ADDENDUM NO. 1

PROJECT: Texas County Airport Road Bridge

PROJECT No.: S&C # P190012

SUBJECT: Project Plans - Barrier Details

SHEET: 2

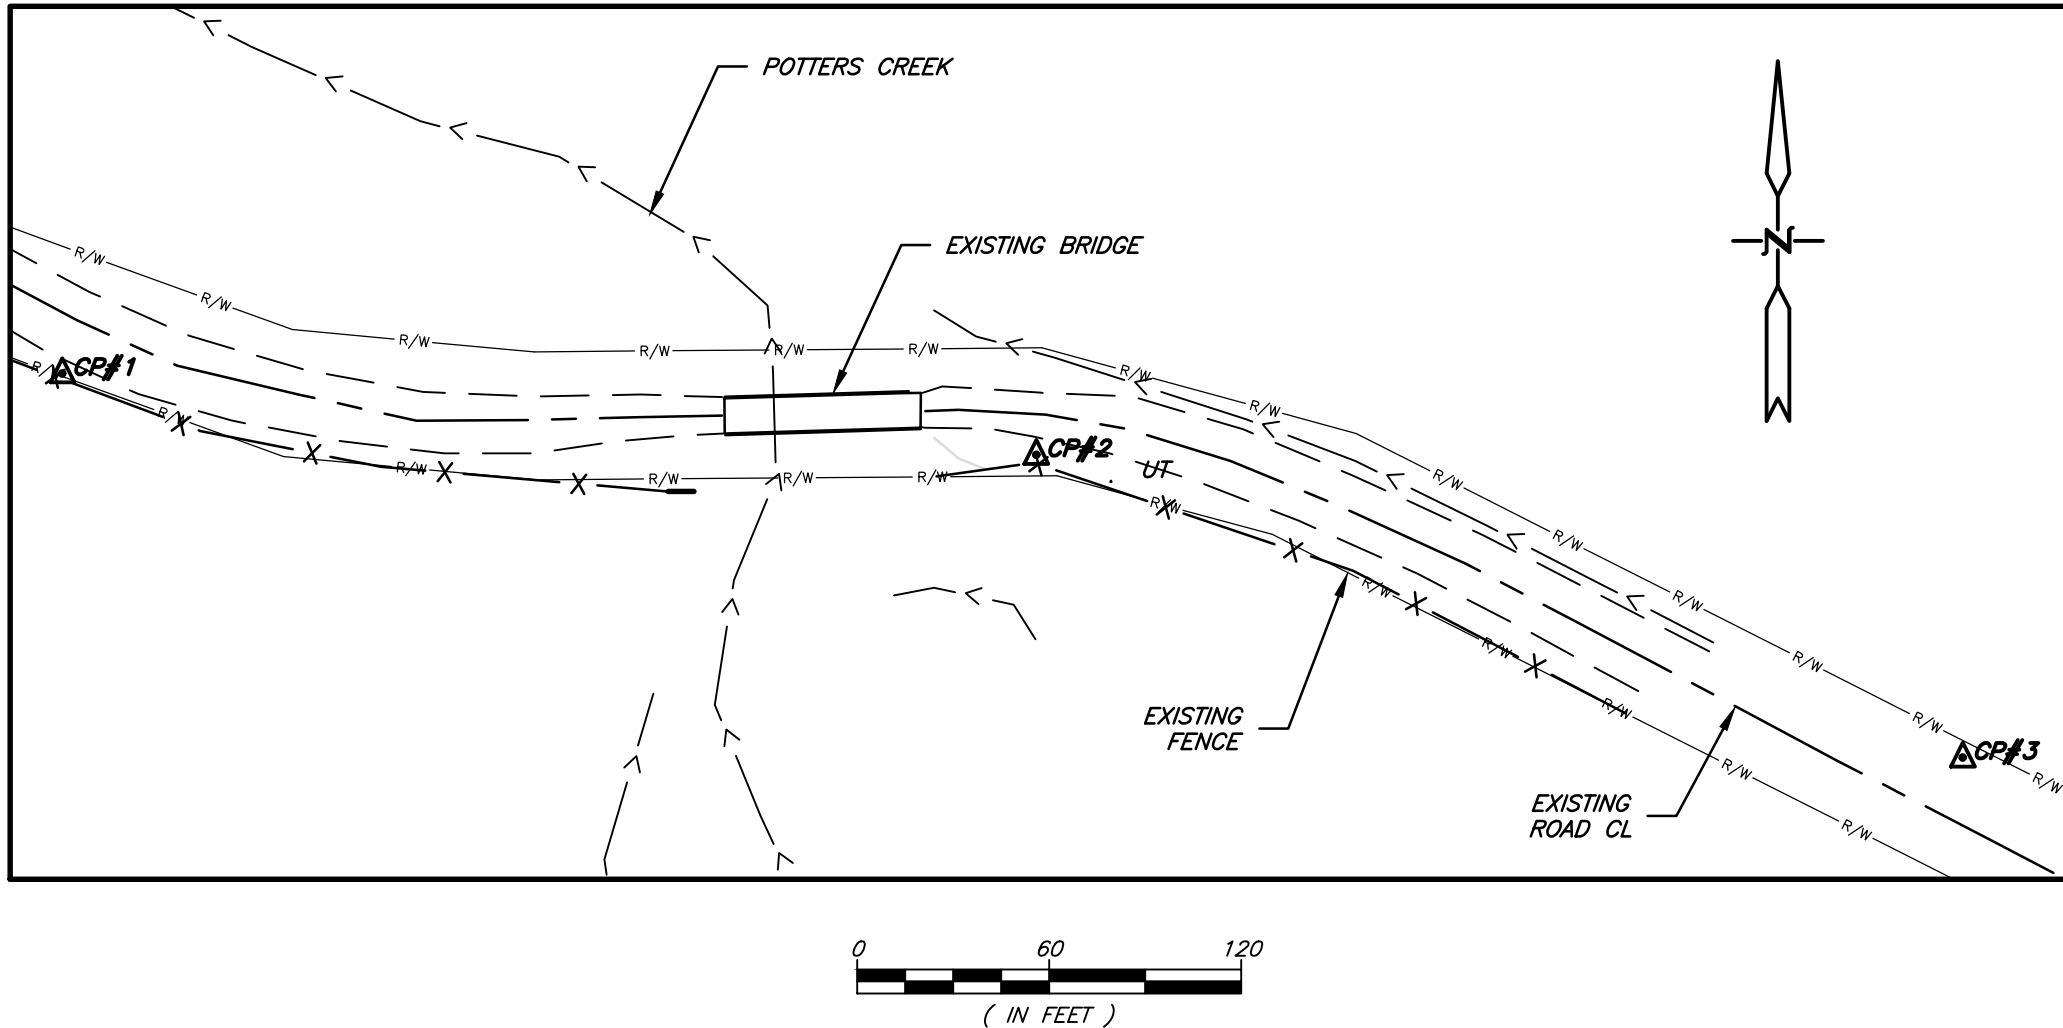
1. Due to a discrepancy, and additional clarification is needed for the overall dimension of the barriers, and fill face length. Please replace plan sheet No. 2, 4, 6 and 12 with the attached revised sheets.

1. The total length of barrier was shown incorrectly on page No. 2 of the project plans and in the original bid schedule in the bid document. Please replace the existing bid schedule with the attached revised schedule.
2. The Basis of Bids showed Type II Rock Blanket, which should have been listed as Heavy Revetment. Also, items 22 and 23 used the incorrect unit. Please replace the Basis of Bids with the attached sheets.

NO.	REVISIONS	DATE	BY	APP.
1	REVISED QUANTITIES	4/13/20	JDM
